Submission: Application no. SSD-93020230

40-48 Redan Street Mosman

Residential Development with In-fill Affordable Housing

Photograph 8: Actual entrance to Redan Ln from Almora St

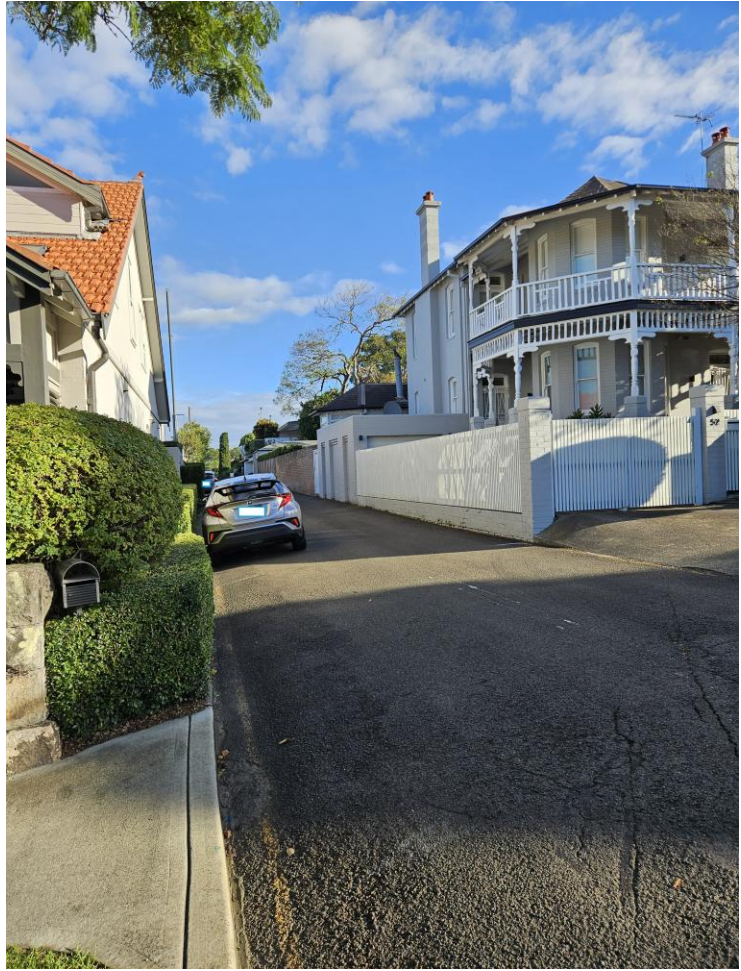
- The lane is too narrow to allow vehicles and pedestrians to use it safely at the same time, particularly when cars are parked along the left-hand side.
- There is no dedicated pedestrian path or footpath, so pedestrians are required to share the same constrained space as moving vehicles.
- The lane does not have the features ordinarily associated with a safe pedestrian route, such as shared-zone treatment, marked pedestrian priority or other traffic-calming measures.
- Lighting in the lane is poor at night, making it harder for drivers to see pedestrians and making the route less safe and less suitable as a pedestrian access way.
- Visibility at the exit of the lane onto Almora Street is poor, particularly in relation to vehicles approaching from the east and turning into the lane, creating an additional conflict point for pedestrians.

The photograph used as Picture 13 in the EIS, described as “Redan Lane view south at the corner of Almora Street”, is taken well into the lane rather than at the actual corner. It does not show the even more constrained conditions at the entrance to the lane from Almora Street.

At the actual entrance to Redan Lane, particularly when cars are parked on the left-hand side, there is clearly insufficient room for vehicles travelling in both directions and pedestrians to use the lane safely at the same time.

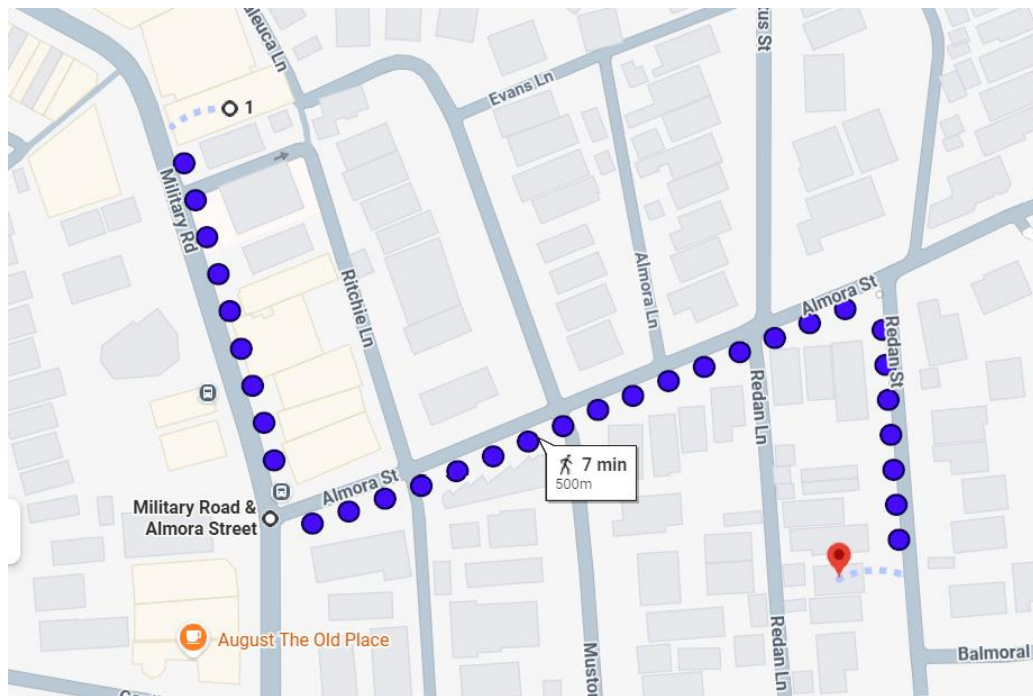
The correct walking route in this instance, being a route that can be safely walked and that uses public footpaths and pedestrian crossings as far as reasonably practicable (as required by the 'walking distance' definition), would involve the following steps:

1. using the public pedestrian crossing at the intersection of Almora Street and Military Road;
2. using the public footpath to travel East down Almora Street; and
3. using the public footpath to travel South down Redan Street.

When using this proper walking route, the walking distance is well in excess of 400 metres (at least 500m), and clearly within the 400 – 800 metre 'LMR outer area', as shown below:
